DOE/AL-62350-235
REV. 1

**LONG-TERM SURVEILLANCE PLAN FOR
THE ESTES GULCH DISPOSAL SITE
NEAR RIFLE, COLORADO**

SUBJECT: Page Changes to the Long-Term Surveillance Plan for the Estes Gulch Disposal Site

**RESPONSE TO NRC COMMENTS
LONG-TERM SURVEILLANCE PLAN
ESTES GULCH DISPOSAL SITE NEAR RIFLE, COLORADO**

FIGURE 3

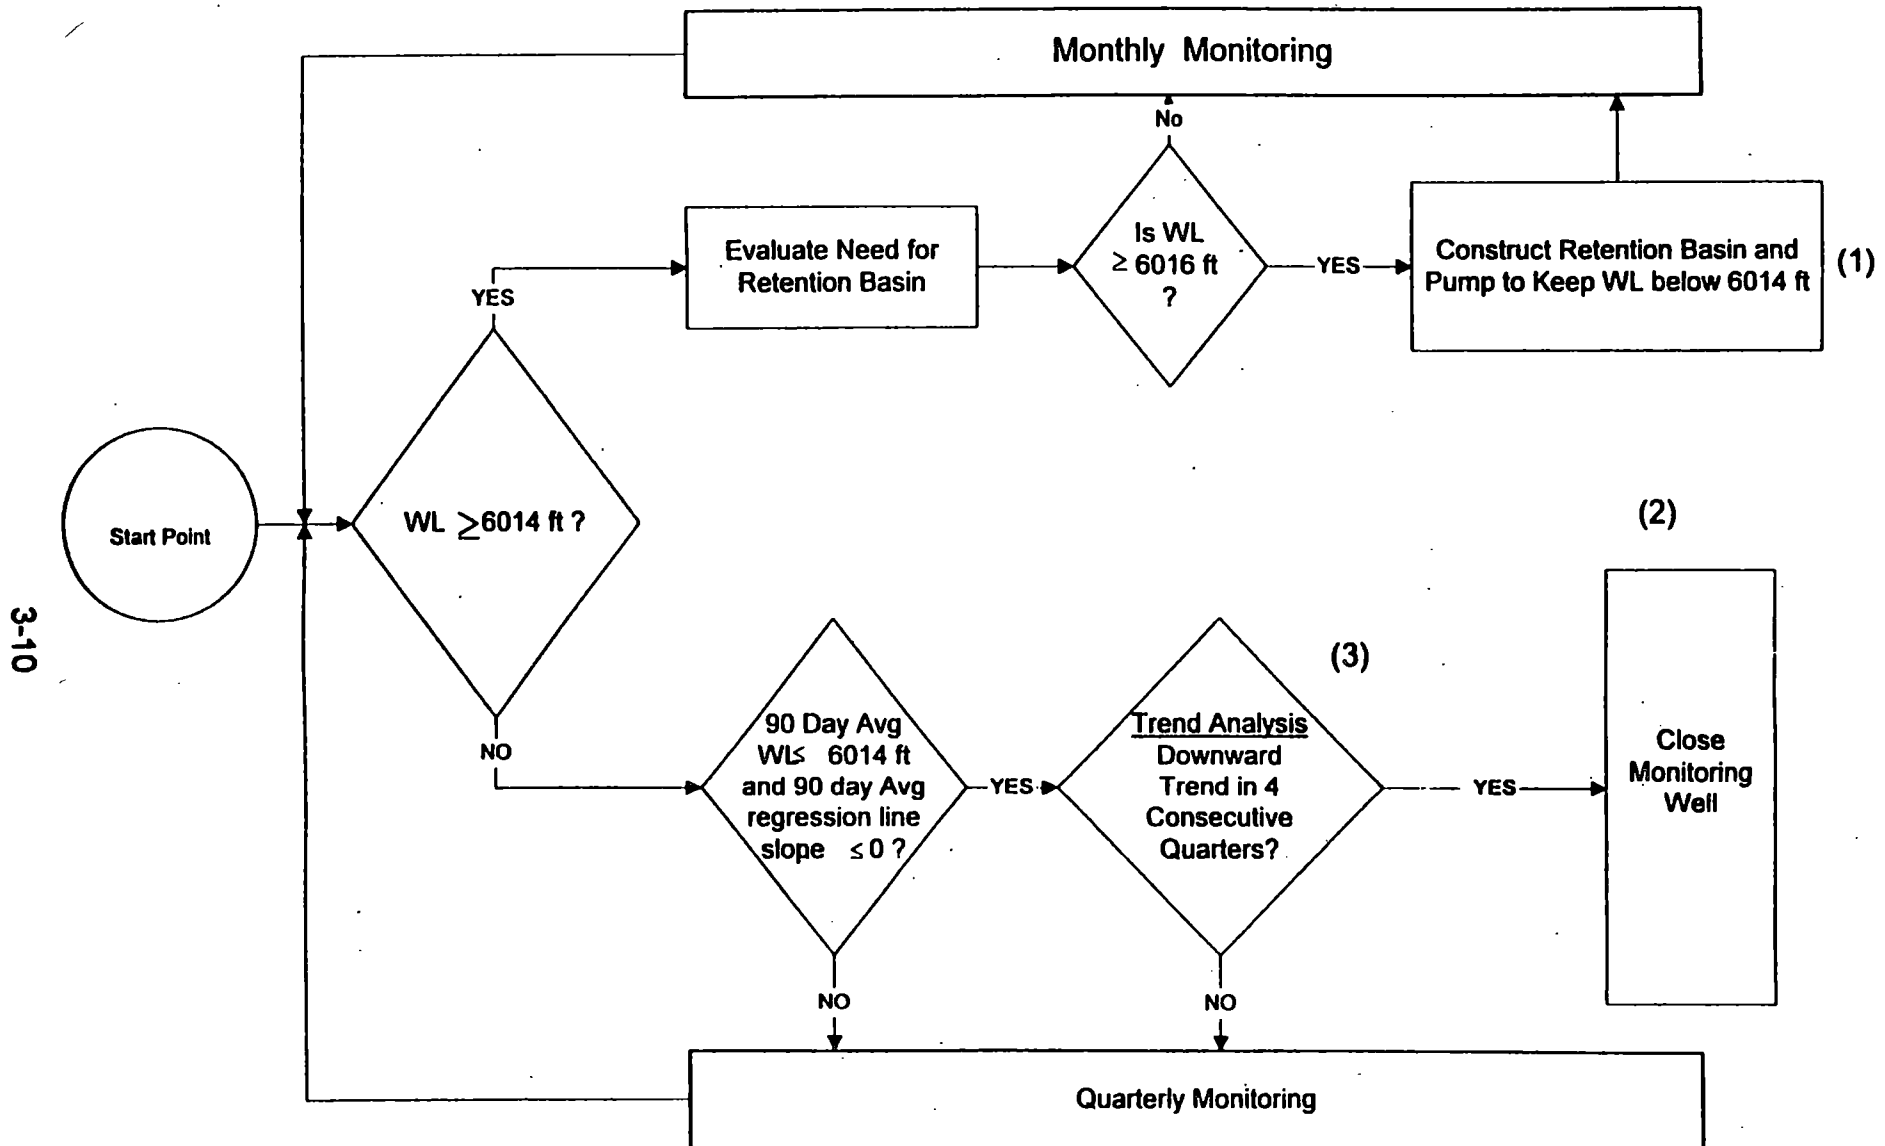
1. Comment: DOE has not explicitly stated that NRC approval will be obtained before the monitoring in the three monitoring wells (standpipes) within the disposal cell is ceased, and the standpipes are abandoned. According to the logic flow chart on page 3-10 of the Appendix, (Figure 3), DOE could abandon the standpipes after four consecutive quarters of a downward trend. Given that these standpipes are the only monitoring being performed to meet the Environmental Protection Agency requirements and this is occurring under the general license, NRC approval should be obtained before the wells are abandoned. DOE should explicitly state in the LTSP (page 2-11, fourth paragraph) that decommissioning the standpipes will occur after NRC approval is obtained. The flow chart in the Appendix should also be modified to reflect that NRC approval should be obtained before closing the monitoring wells.

2. Comment. The LTSP indicates that a linear regression will be plotted and when a zero or negative slope for four consecutive quarters is observed, the wells will be closed. The CDPHE previously had commented that a statistical test such as the Mann-Kendall test be run to test for a significant trend. We do not object to using the linear regression, but are not sure the regression can detect a trend if the slope is zero or only slightly negative. My understanding is that this indicates no trend at all. CDPHE still feels that there will still be a need for detecting and estimating statistically significant trends by using a test such as Mann-Kendall or Sen's nonparametric estimator. Whichever method is used would have to analyze data for two wells and multiple data points.

Response: LTSP page 2-11, fourth paragraph of Section 2.4, has been modified to require state review and NRC approval for closure of the standpipes. In addition, Figure 3 in the Appendix has been changed to show a state review and NRC approval step for decommissioning the standpipes.

Response. As committed in response to NRC Comment 1, the LTSP page 2-11, fourth paragraph of Section 2.4, has been modified to require state review and NRC approval prior to closure of the standpipes. In addition, Figure 3 in the Appendix has been change to show this step. This change will provide CDPHE the ability to provide comments and concerns prior to well closure.
